D3100 LLW Disposal Facilities

Application to SEPA for a variation to EAS/P/1173599 - Supporting Document

Reference number:	D3100/4/REP/INT/40185/IS/02
Issue Status:	Issue 2
Issue Date:	28 May 2021
ESC Document Hierarchy:	Level 3

APPENDIX E PROPOSED SITE PLAN

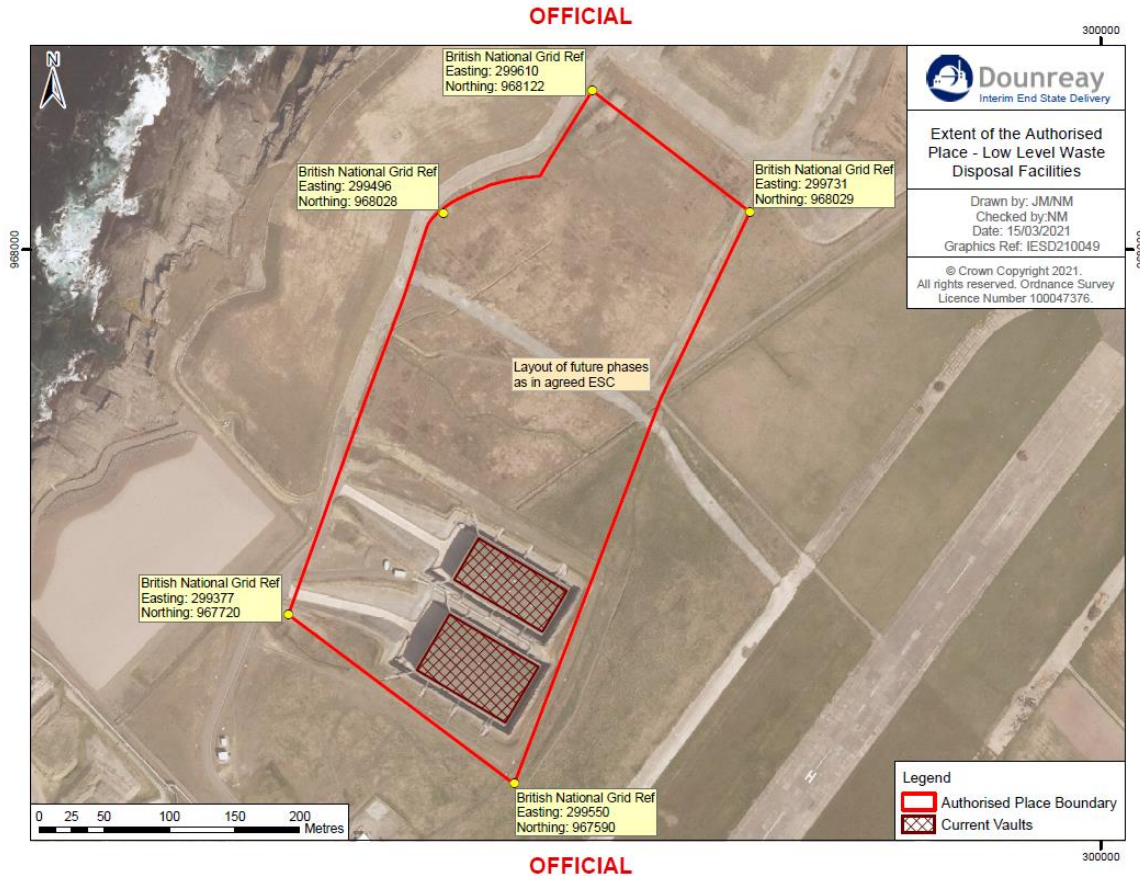
50 It is highlighted that during the pre-application dialogue with SEPA, it was identified that for the Site Plan in Schedule 3 to remain valid it should reflect the ‘as-built’ status of the vaults and will therefore require to be updated for each future phase of vault construction. A revised Site Plan is presented in Appendix E. Future updates to Schedule 3 will require a minor variation to the EASR permit.

EASR Bespoke Condition	EASR Bespoke Condition wording	Request	Justification
	Schedule 3	DSRL request that the site plan is amended to remove the detail of proposed future phases (see Appendix E)	In line with proposals for Conditions 7.1, replacing detailed design assumptions on the Site Plan with a note that the layout of future phases as in the agreed Environmental Safety Case (ESC) ensures ongoing optimisation of the facility design and optimisation in line with regulatory requirements. It also ensures compliance with Condition 6.2 which requires the ESC to be updated at intervals agreed with SEPA.
